SUNDRY NOTICES AND REPORTS ON WELLS

Mobil Apache 20

Proposed P&A

CONDITIONS OF APPROVAL

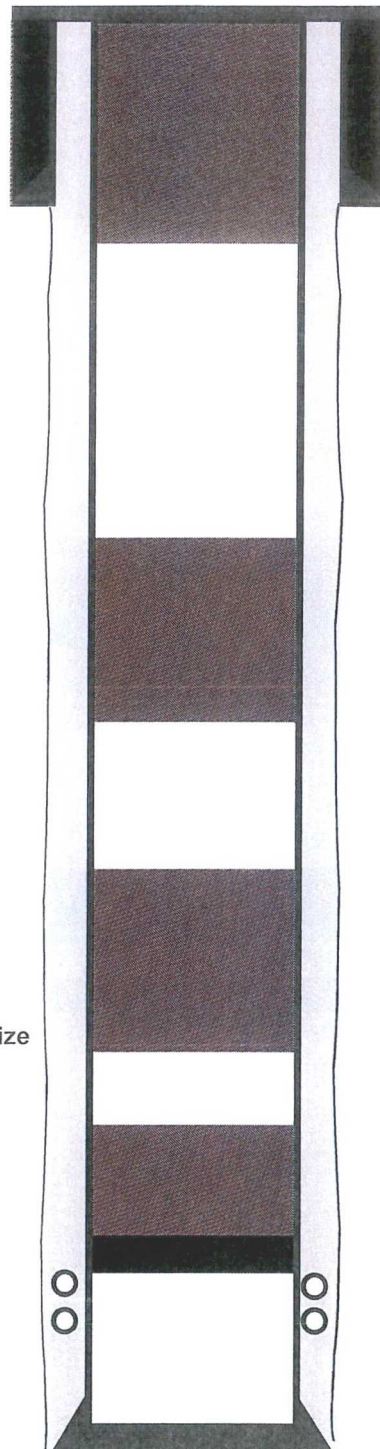
- a) Combine Plugs #1, #2 and #3 (3022 – 2754) ft. to cover the PC, Fruitland, Kirtland, and Ojo Alamo tops. BLM picks top of Fruitland at 3010 ft. BLM picks top of Kirtland at 2974 ft. BLM picks top of Ojo Alamo at 2804 ft.
- b) Add a cement plug (1518 – 1418) ft. to cover the Nacimiento top. BLM picks Nacimiento top at 1468 ft.
- c) Set Plug #4 (150 – 0) ft. to cover the 8-5/8" surface casing shoe. Surface casing shoe at 100 ft.

You are also required to place cement excesses per 4.2 and 4.4 of the attached General Requirements.
